Modifikation von Mikroprozessorkarten

Modification of microprocessor boards

Under part number **20.050.754.12** a **modification kit** is available for all processor cards 1.820.754.12 used in the recorders A820, A820 MCH and A827.

1.820.754.12

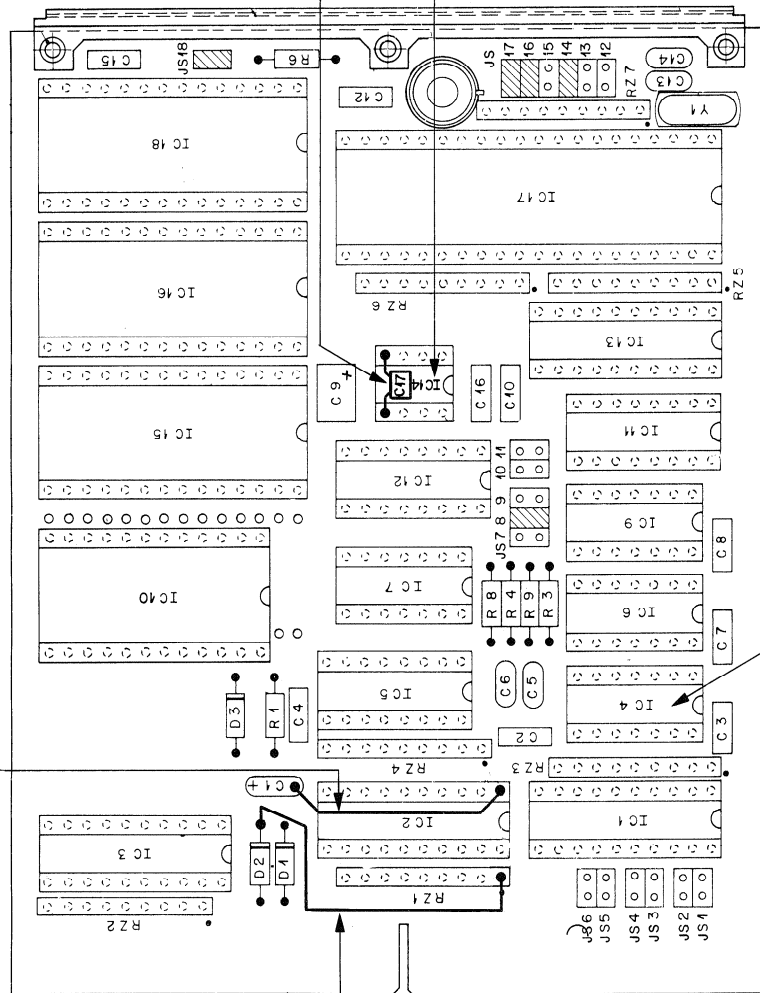
- IC 14, TL 7705 ACP entfernen, dafür neu TL 7705 BCP einsetzen.
- IC 2,2nF zwischen PIN 4 und 5 von IC 14 einlöten.
- IC 4, 74 HC 00 ersetzen durch Typ 74 HC 132.
- Wire-Wrap Draht l=90 von D2 (Kathode) auf PIN 1 von RZ1.
- Wire-Wrap Draht l=80 von C1 (negativ) auf PIN 1 von IC2.
- Neues, um 1 erhöhtes Indexschild auf dem Beschriftungsstreifen anbringen.

- Replace IC 14, TL 7705 ACP with TL 7705 BCP
- Fit C 2,2nF capacitor between pin 4 and 5 of IC 14
- Replace IC 4, 74 HC 00 with 74 HC 132
- Connect cathode of D2 with pin 1 of RZ1 (wire length 90mm)
- Connect C1 (negative) to pin 1 of IC2 (wire length 80mm)
- Fit index label of next higher number to legend strip.

WIRE WRAP 80mm
1.010.108.64 ★

WIRE WRAP 90mm
1.010.109.64 ★

2,2nF, 10%, 63V
59.06.0222 ★

IC14 CHANGE TO TL 7705 BCP

IC4 CHANGE TO 74 HC 132
50.17.1132
